TULSA PARK ESTATES SUBDIVISION, **RESUBDIVISION OF LOT 6**

APPLICATION NUMBER 4 DATE October 19, 2017
 APPLICANT Tulsa Park Estates Subdivision, Resubdivision of Lot 6
 REQUEST Subdivision

DETAIL SITE PLAN

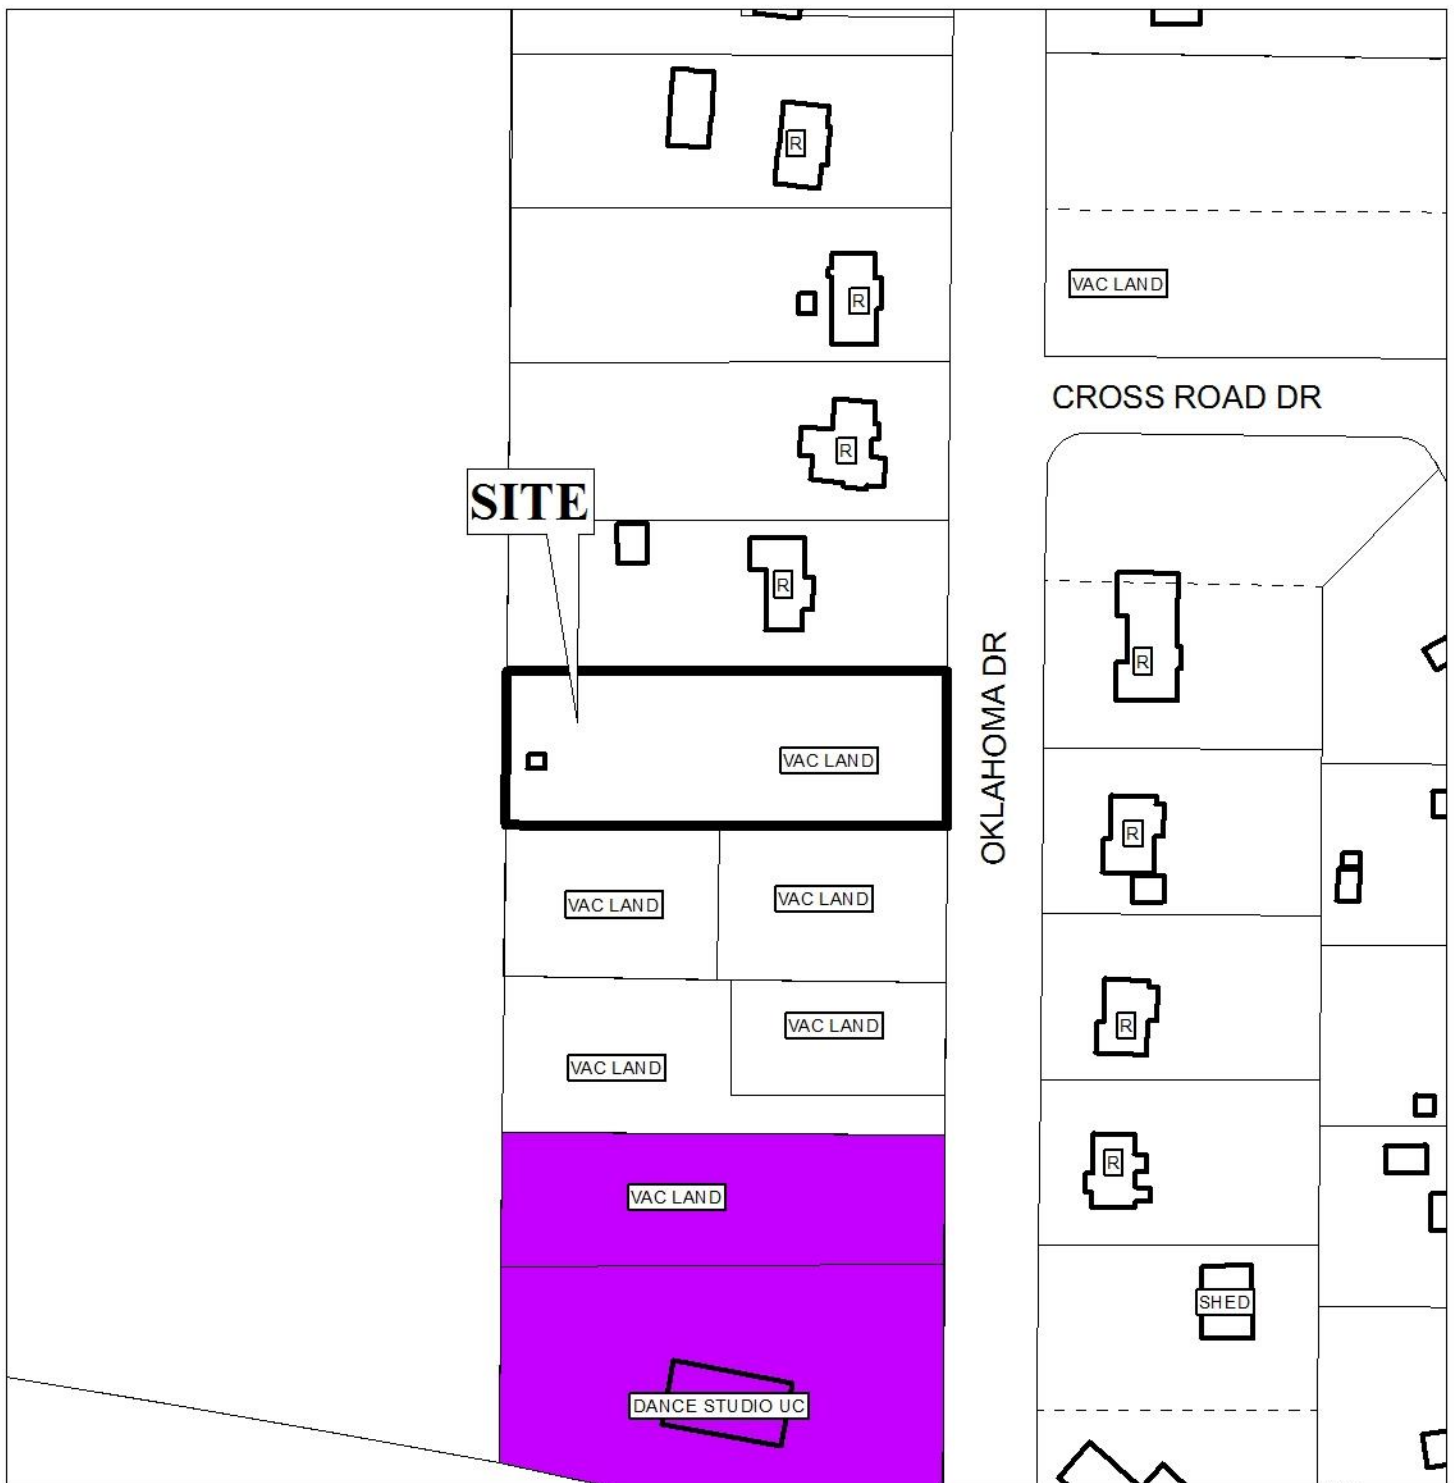
- A. REMOVE THE MOBILE COUNTY ENGINEERING DEPARTMENT NOTE. THIS PROPOSED SUBDIVISION IS LOCATED WITHIN THE CITY LIMITS. THE COUNTY ENGINEER NO LONGER SIGNS PLATS WITHIN THE MUNICIPAL LIMITS OF THE CITY OF MOBILE.

- B. Provide all of the required information on the SUBDIVISION PLAT (i.e. signature blocks, signatures, certification statements, written legal description, required notes, legend, scale, bearings and distances) that is required by the current Alabama State Board of Licensure for Professional Engineers and Land Surveyors.

- C. Provide and label the monument set or found at each subdivision corner.
- D. Provide the Surveyor's, Owner's (notarized), Planning Commission, and Traffic Engineering signatures.

- E. Add a note to the SUBDIVISION PLAT stating that as shown on the 1984 aerial photo (FLIGHT 18 - #74) LOTS 1 and 2 will have to share the historical credit of existing (1984) impervious area towards stormwater detention requirement per Mobile City Code, Chapter 17, Storm Water Management and Flood Control). Coordinate with City Engineering Department staff to establish the exact amount that each Lot will receive prior to the submittal of the Final Plat from review and signatures.

- F. Add a note to the SUBDIVISION PLAT stating that a Land Disturbance permit will be required for any land disturbing activity in accordance with Mobile City Code, Chapter 17, Storm Water Management and Flood Control); the City of Mobile, Alabama Flood Plain Management Plan (1984); and, the Rules For Erosion and Sedimentation Control and Storm Water Runoff Control.

- G. Add a note to the Plat stating that the approval of all applicable federal, state, and local agencies (including all storm water runoff, wetland and floodplain requirements) will be required prior to the issuance of a Land Disturbance permit.

- H. Add a note that sidewalk is required to be constructed, and/or repaired, along the frontage of each lot, or parcel, at time of new development or construction, unless a sidewalk waiver is approved.

The proposed lots front Oklahoma Drive, a minor street with ribbon curb and gutter. As a minor street with ribbon curb and gutter, this street requires a minimum right-of-way width of 50 feet. The right-of-way width is indicated as 60 feet on the preliminary plat, and should be retained as such on the Final Plat, if approved.

It should be noted that the proposed lot configurations create an irregular shaped Lot 2. The proposed Lot 2 forms a “panhandle” or “flag lot” shape, and is generally not allowed, but permitted only in those locations where varied and irregularly shaped lot designs are common

The 25-foot minimum building setback line is depicted on the preliminary plat for each proposed lot, and should be retained on the Final Plat, if approved.

The proposed lots exceed the 7,200 square foot minimum lot size requirements for lots served by public water and sanitary sewer systems. The lot size information is indicated in both acres and in square feet, and if approved, should be retained on the Final Plat.

As a means of access management, a note should be placed on the Final Plat stating that each lot is limited to one curb-cut to Oklahoma Drive, with any changes to the size, location and design to be approved by Traffic Engineering and conform to AASHTO standards.

Finally, there should be no future subdivision of either proposed lot to create additional lots. This should be placed as a note on the Final Plat, if approved.

- 1) Placement of a note on the Final Plat stating that there should be no future subdivisions of either lot to create additional lots;
- 2) Retention of the right-of-way width along Oklahoma Drive;

- 3) Retention of the 25-foot minimum building setback line;
- 4) Retention of the lot size information in both square feet and in acres;
- 5) Placement of a note on the Final Plat stating that each lot is limited to one curb-cut to Oklahoma Drive, with any changes to the size, location and design to be approved by Traffic Engineering and conform to AASHTO standards;
